Special Use Permit #2024-00041
404-A East Alexandria Avenue

Application	General Data	
Public Hearing and consideration of requests for Special Use Permits to construct a single-unit dwelling on a vacant substandard lot and for a lot without frontage on a public street	Planning Commission Hearing:	November 7, 2024
	City Council Hearing:	November 16, 2024
Address: 404-A East Alexandria Avenue	Zone:	R-2-5/ Residential
Applicant: Eric Teran and Daniela Gross	Small Area Plan:	Potomac West

Staff Recommendation: APPROVAL subject to compliance with all applicable codes, ordinances, and the recommended permit conditions found in Section III of this report.

OPTION 2

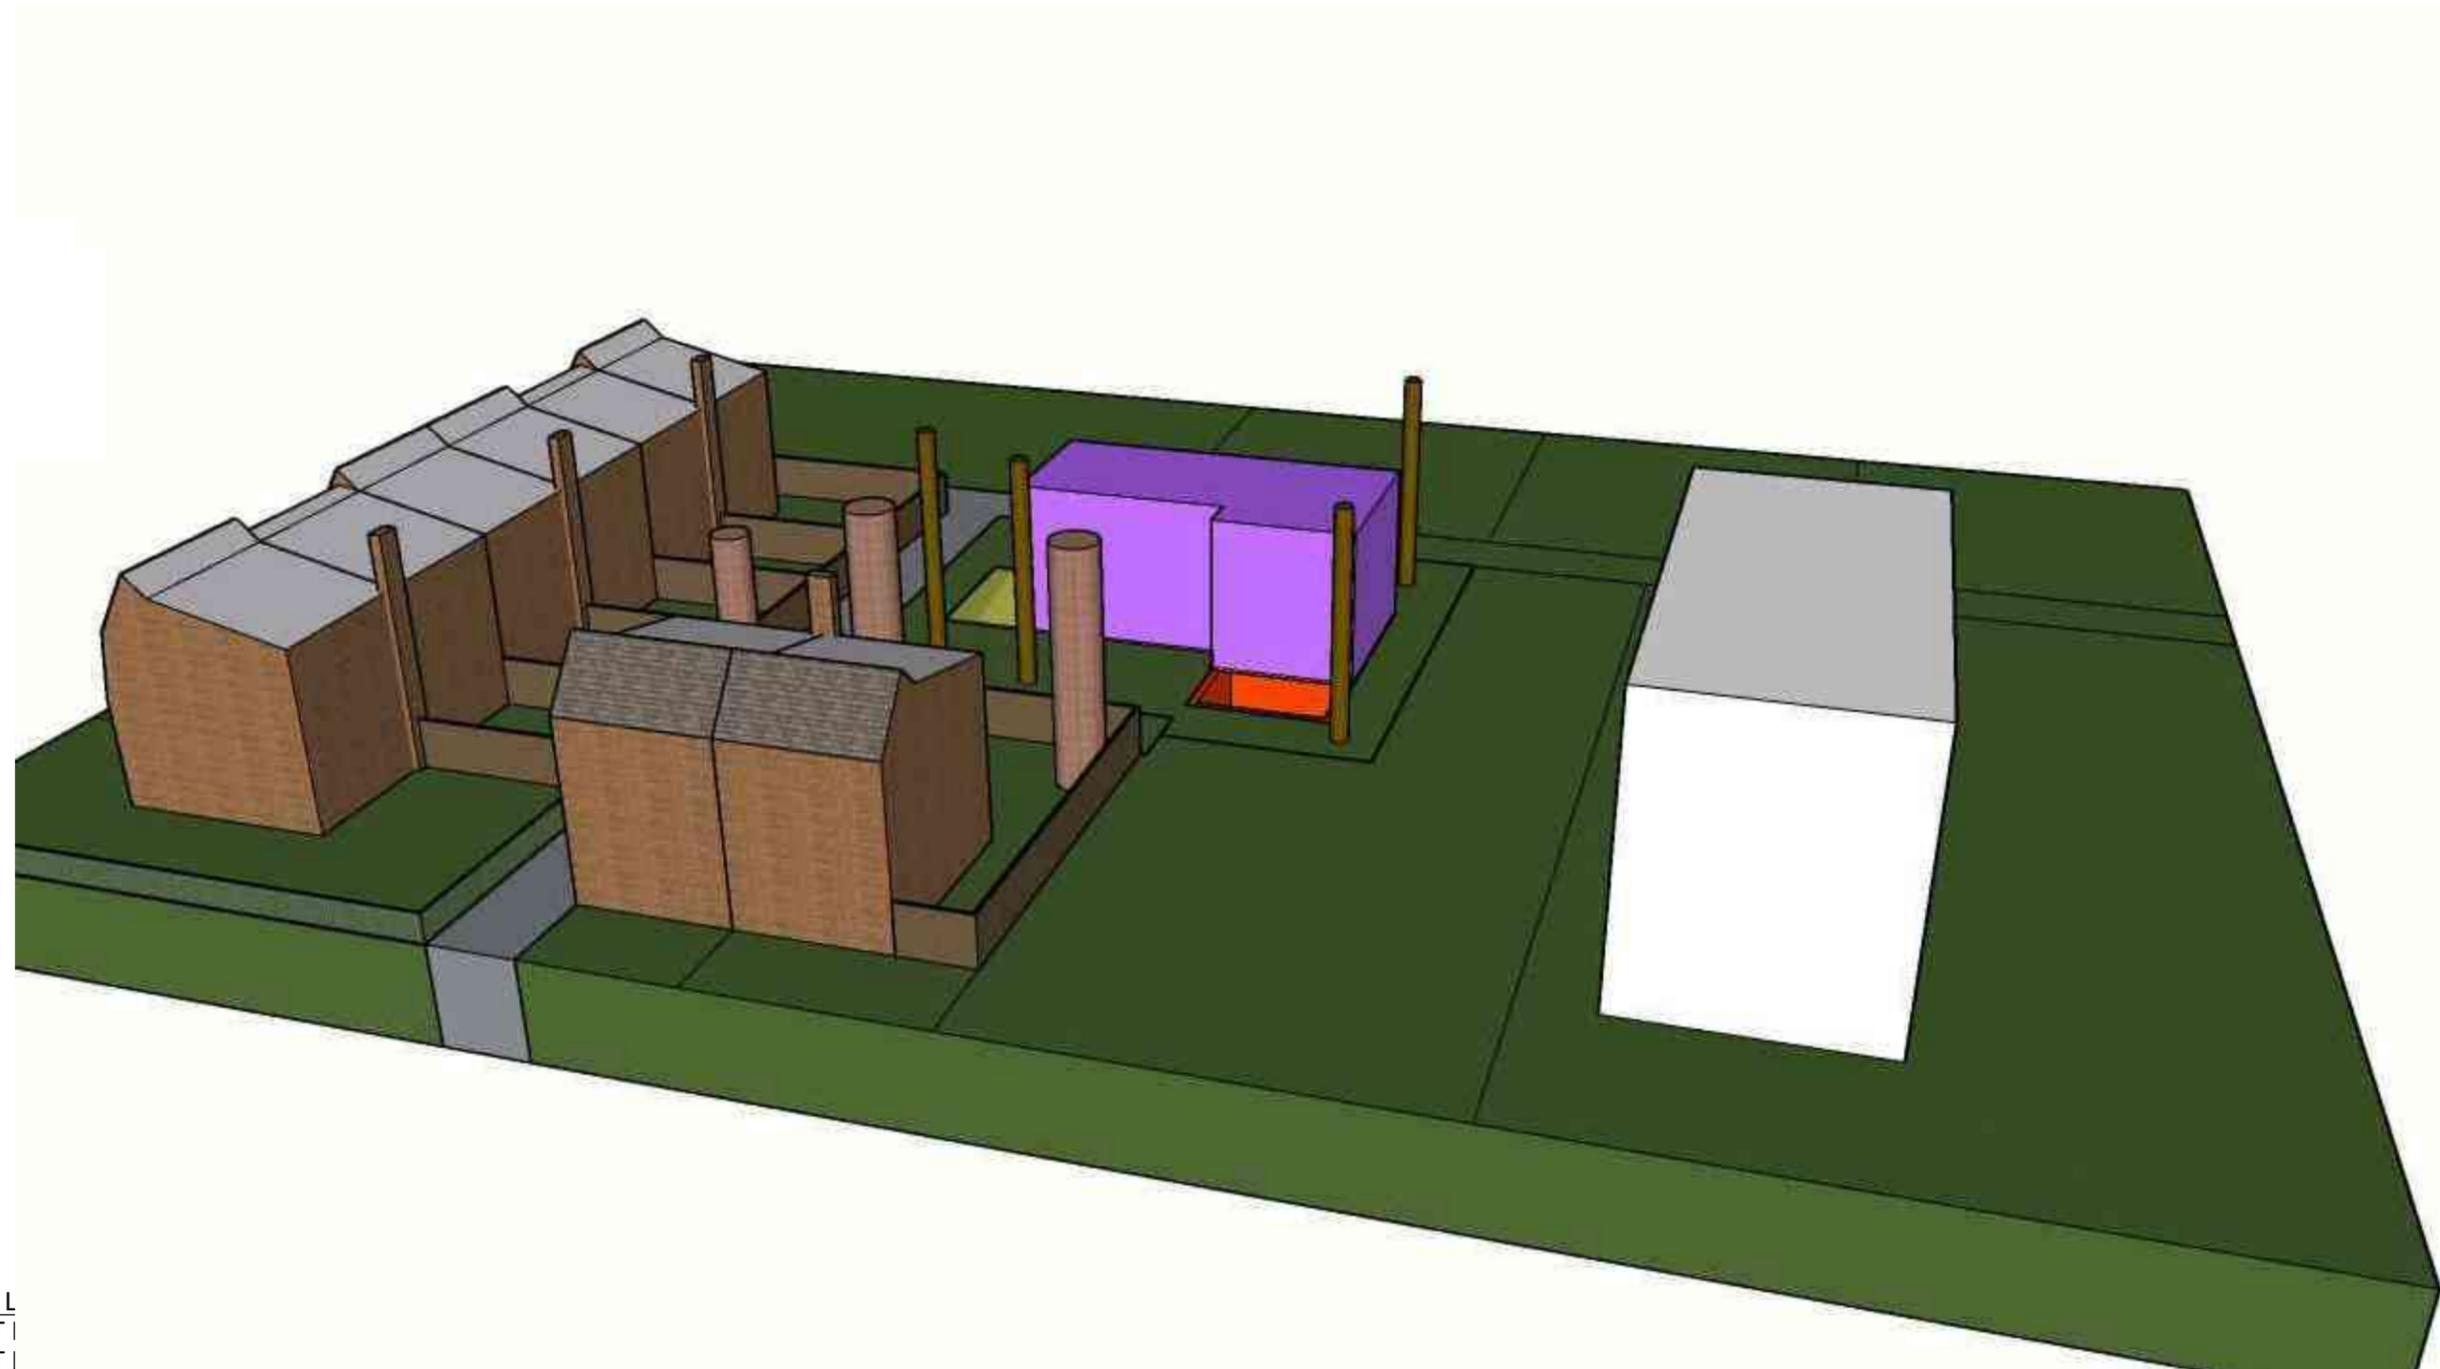
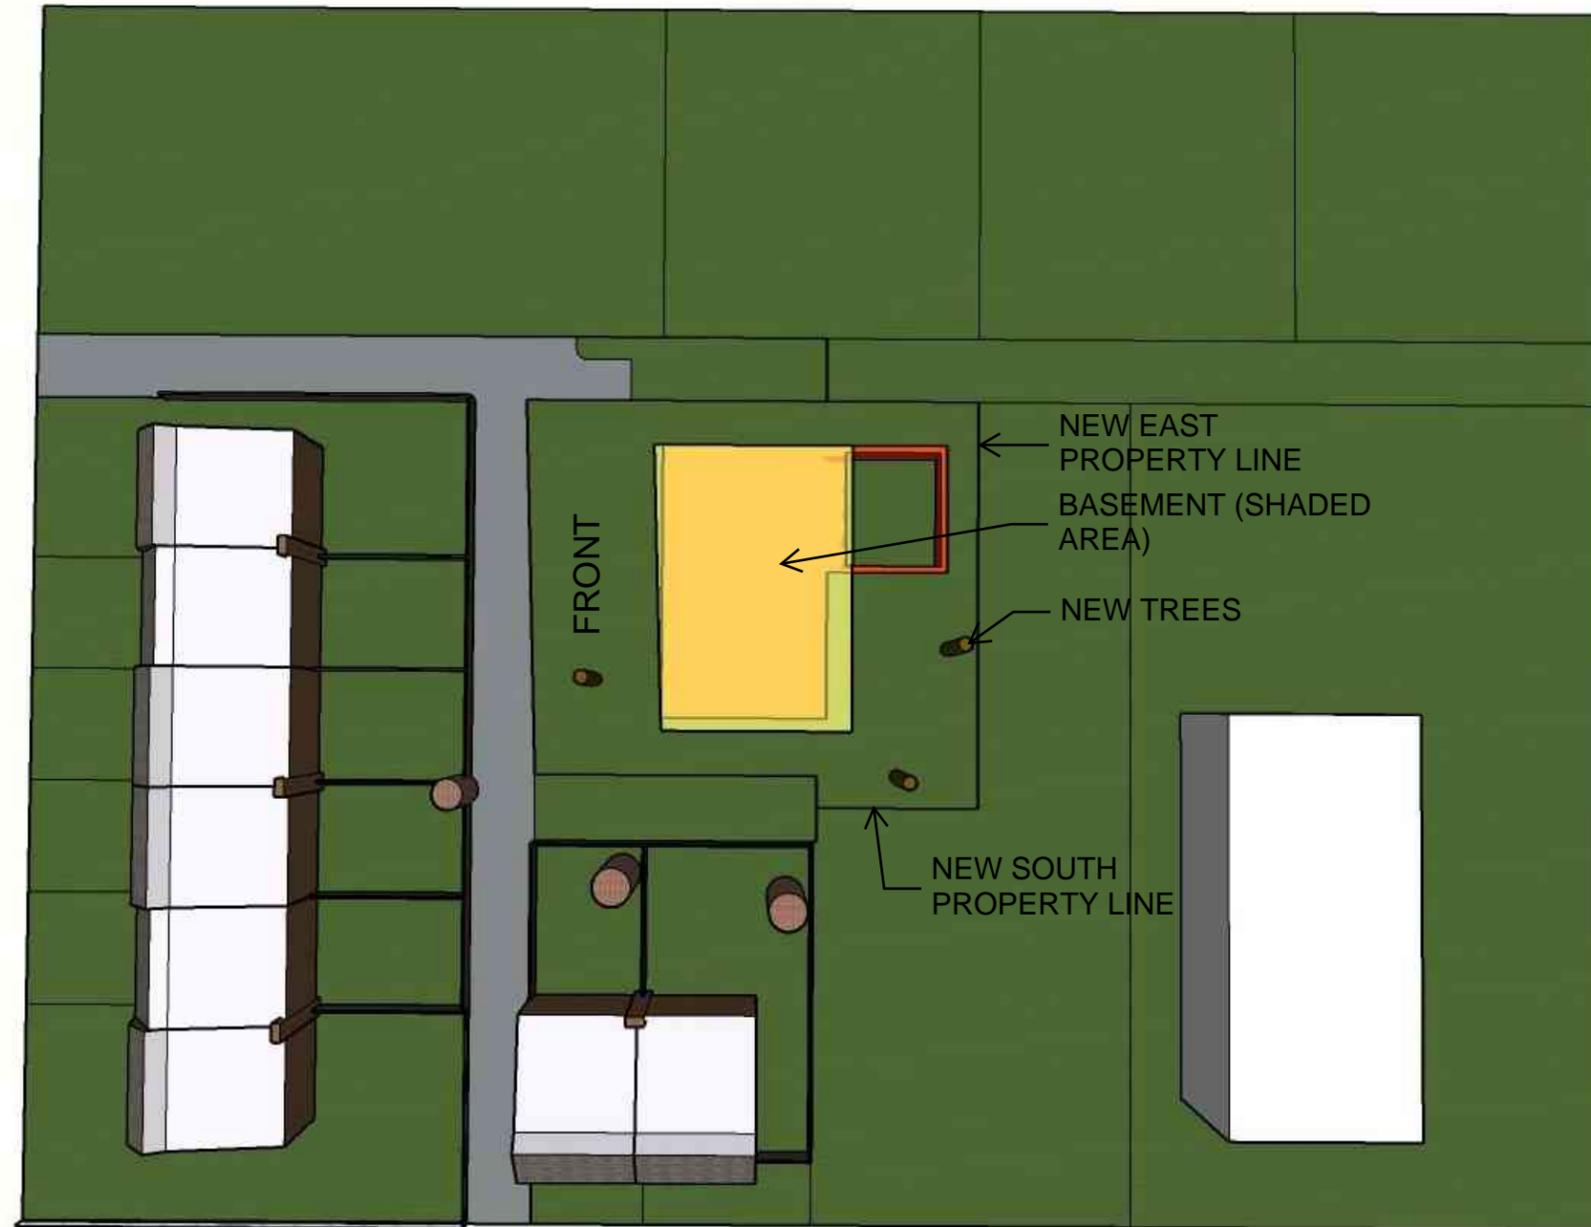
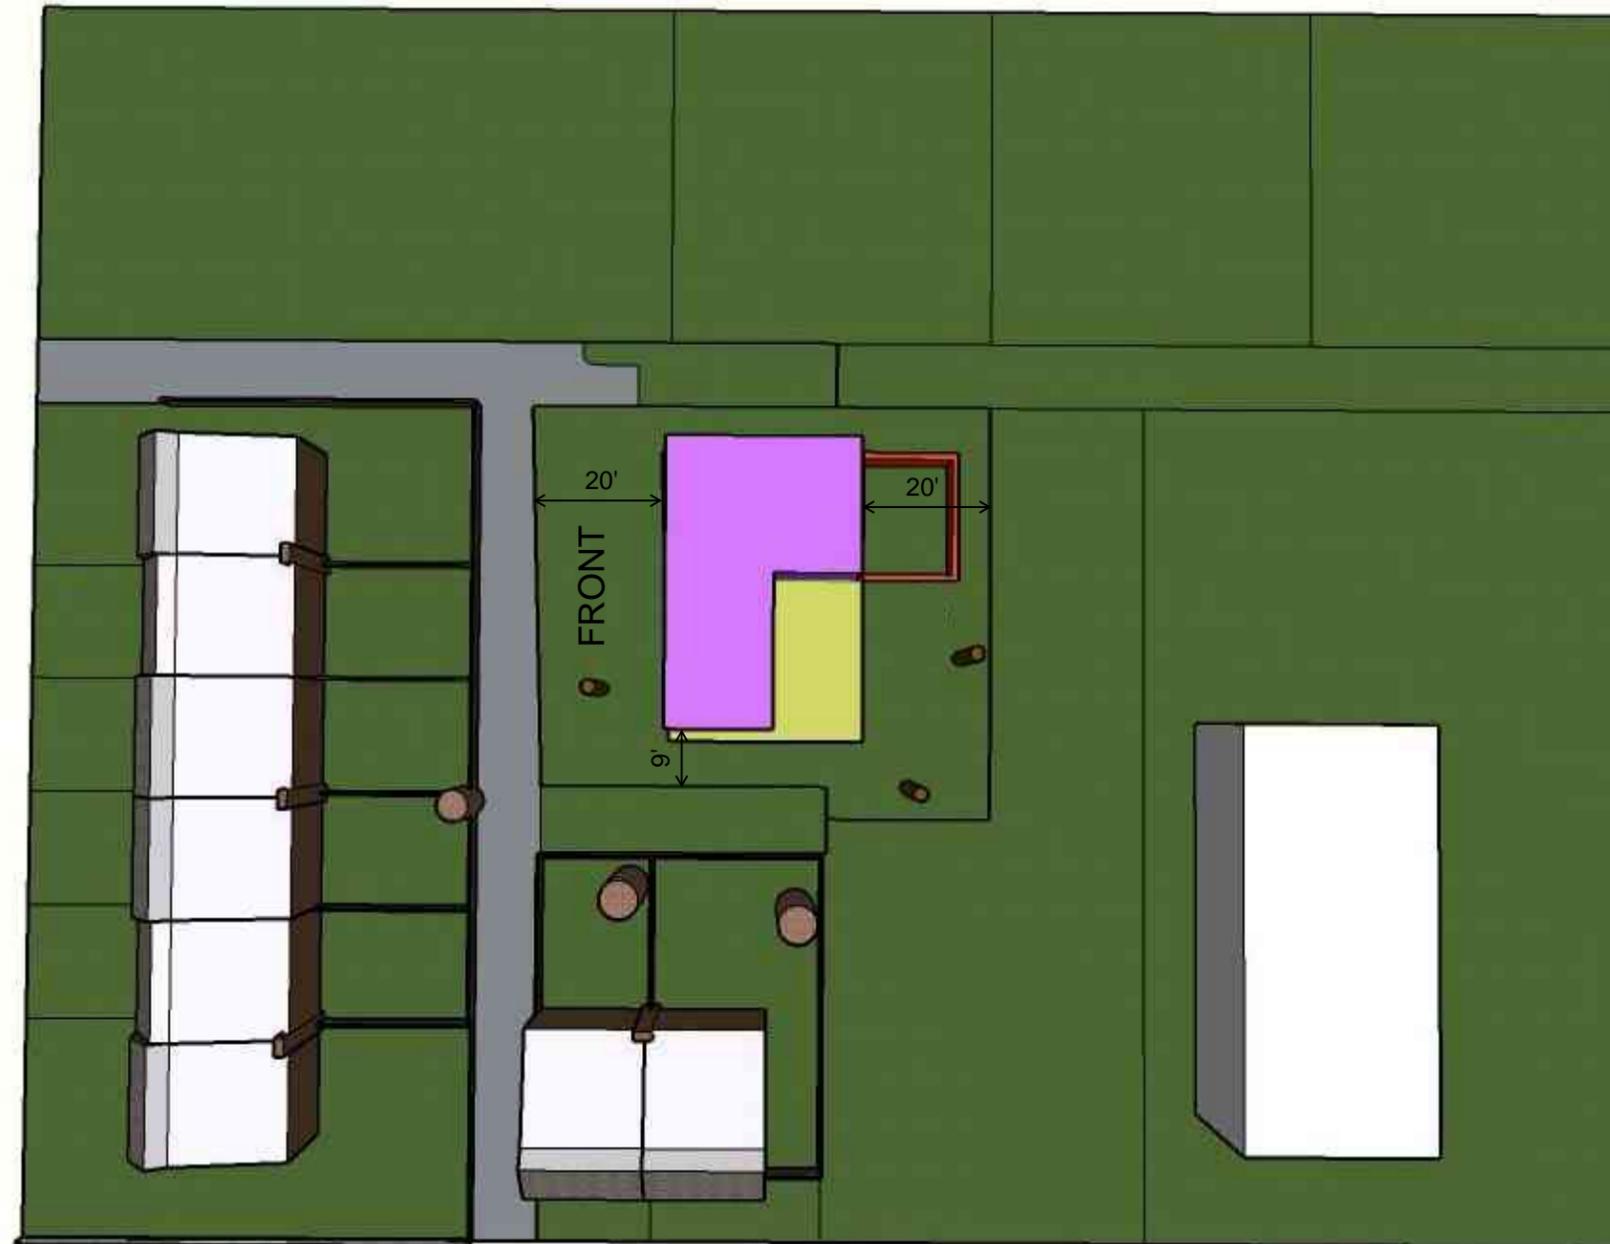
1. NEW LOT SIZE PER APPROVED VACATION REQUEST
2. MAINTAIN ORIGINAL BASEMENT DESIGN
3. PROTECT EX. SILVER MAPLE TREE

1. REMOVE THE SILVER MAPLE TREE AND PLANT 3 - 4 NEW TREES

2. THE BASEMENT IS RECONFIGURED AND CONTAINED WITHIN THE ABOVE GRADE BUILDABLE AREA.

1. THE ABOVE GRADE FLOORS ARE SHIFTED TO THE EAST PROVIDING A SETBACK OF 18'-0" FROM THE ALLEY. THE ORIGINAL DESIGN IS 7'-0".

1. THE HOUSE IS MORE VISIBLE FROM E. ALEXANDRIA AVE.

1. THE FRONT YARD IS ON THE WEST SIDE OF THE PROPERTY CREATING A DIFFERENT BUILDABLE AREA
2. REMOVE THE SILVER MAPLE TREE AND PLANT 3 - 4 NEW TREES
3. THE BASEMENT IS RECONFIGURED AND CONTAINED WITHIN THE ABOVE GRADE BUILDABLE AREA.

2. THE SOUTH FACADE IS NOW ONLY 9'-0" FROM THE PROPERTY LINE COMPARED TO 19'-10" IN THE ORIGINAL DESIGN.

3. THE "L" SHAPE PROVIDES LESS VISIBILITY FROM E. ALEXANDRIA AVE.

1. THE "L" SHAPE AND VEGETATION PROVIDES LESS VISIBILITY FROM E. ALEXANDRIA AVE.
